Proposal for amendments to ECE/TRANS/WP.29/GRSP/2012/21

Proposal for Supplement 7 to the 04 series of amendments

The text reproduced below was prepared by the expert from the France on behalf of the Technical Services Group (TSG) on UN Regulation No. 44. It aims to clarify the lap strap interaction with the dummy and its assessment as well as improving the overturning test procedure in light of recent findings. The modifications to the current text of the UN Regulation are marked in bold for new or strikethrough for deleted characters.

Load application device I (to be used for Group 0 / 0+ products)

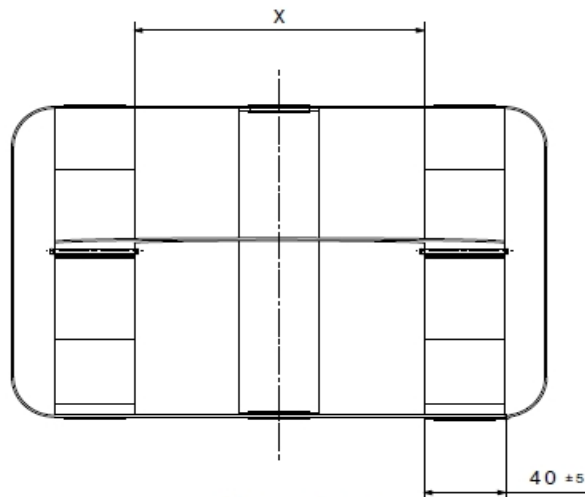
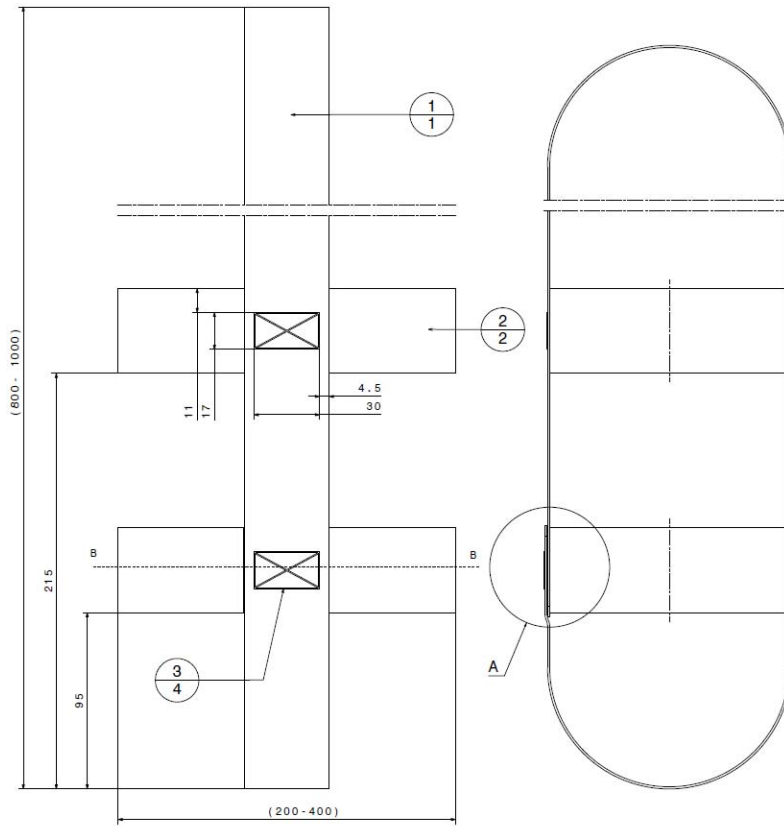
Insert a new Annex 23, to read:

"Annex 23
